**Title:** WorkStar Hybrid Mount to Pad Mount A/C Compressor Retrofit

**Applies To:** WorkStar

A/C compressor update from hybrid mount to direct mount to engine.

Figure 1 - Broken Hybrid Compressor Mount

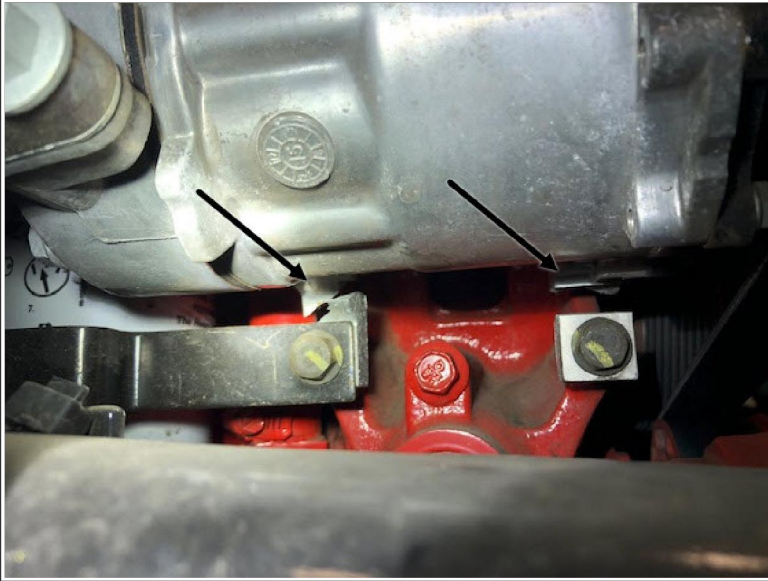
Step	Action	Decision
1	<p><b>DIAGNOSTIC:</b></p> <p>Inspect A/C compressor mounting and engine serpentine belt.</p> <p>Is A/C compressor belt off, broken, or shredded?</p> <p>Is the A/C compressor loose (broken mounts)?</p> <p>Refer to Figure 1 for example of broken compressor mounts.</p>	<p><b>Yes:</b> Refer to Service Parts Information listed above:</p> <ul style="list-style-type: none"> <li>• Order all needed parts listed for application</li> <li>• <b>Refer to Figure 2 High Visibility/Sloped Hood only (09WBM)</b></li> <li>• Cut out template per directions</li> <li>• Follow removal procedure</li> <li>• Follow installation procedure</li> </ul> <p><b>No:</b> Reference HVAC System Diagnostics in service portal</p>

Figure 3 - Frame Modification - Passenger Side Only

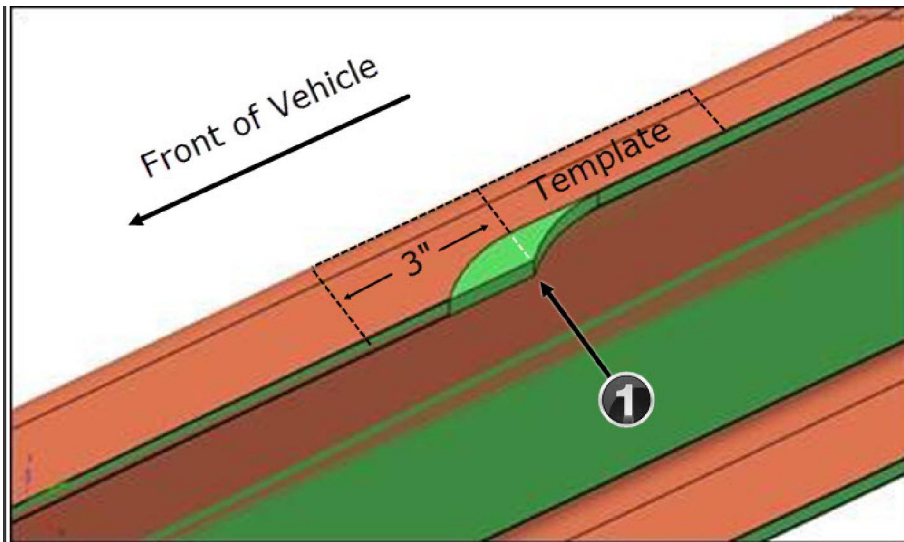
On low visibility / sloped hood units a 50 mm extended frame modification is required for compressor clearance during engine torque roll. Use included template (Figure 2).

1. Print the iKNow article
  - Must be printed at 100% on 8 1/2" x 11" Paper
  - Measure 3 inches on front of template to verify the template has printed at the correct size
2. Cut out and place on right side frame rail (Passenger side)
3. Align dotted line up with point on old bevel (Figure 3, Item 1)
  - The white dashed line is showing alignment to the old bevel
4. Mark the frame. Then grind / cut area that is shown in **light green** (Figure 3, Item 1) (**Do not use a torch**)
  - This is for compressor clearance during engine torque roll on vehicles with High Visibility / Sloped hood only (09WBM)
  - It is critical to follow template, must have beveled edge, do not square cut or notch the frame - "Could cause frame to crack"
  - You are only removing a small sliver of frame rail flange (Shown in light green)
    - You are NOT removing material the size of the template

11. Disconnect Clutch, A/C Compressor / From Harness
12. Remove Compressor, A/C / From Engine Two Bolts One Nut
13. NOTE: Block Off Wiring Harness with Thin Metal Plate. As Some Cutting Tools Will Throw Sparks At Harness.
14. **(High Vis/Slope hood only)** Cut Frame Following Mark Made with Template. Clean / Any Burrs Or Sharp Edges **(Do not use a torch)**
15. Clean Frame Area with Cleaner To Remove Oils
16. **(High Vis/Slope hood only)** Apply / Paint To Frame Area
